ADDENDUM NO. 2

Project:	Monon Center Indoor Playground	Project Number:	2023-020
Location:	195 Central Park Dr W. Carmel, IN 46032	Date Prepared:	26 April 2024
Owner:	Carmel Clay Parks and Recreation	Bid Package:	
		Distributed to:	ALL PLAN HOLDERS

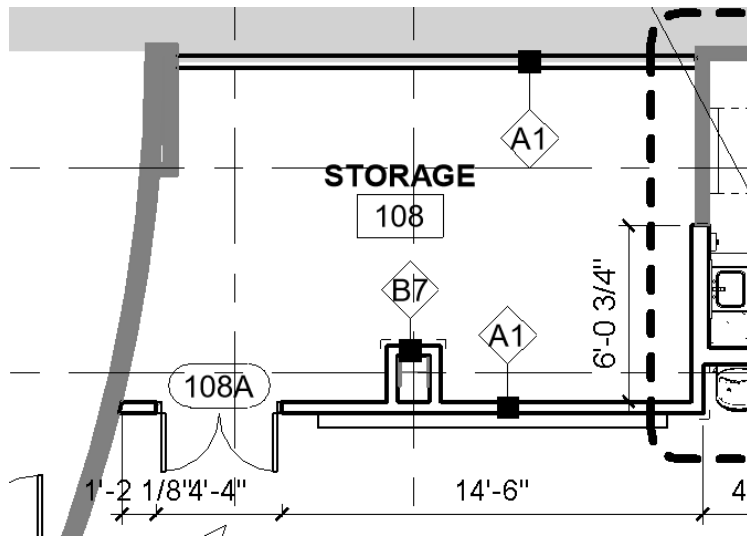
12. Can you provide more Details on the Tree?
 - a. See image for a similar installation. CAD files can be provided to selected contractor for the shapes of the "trunk"
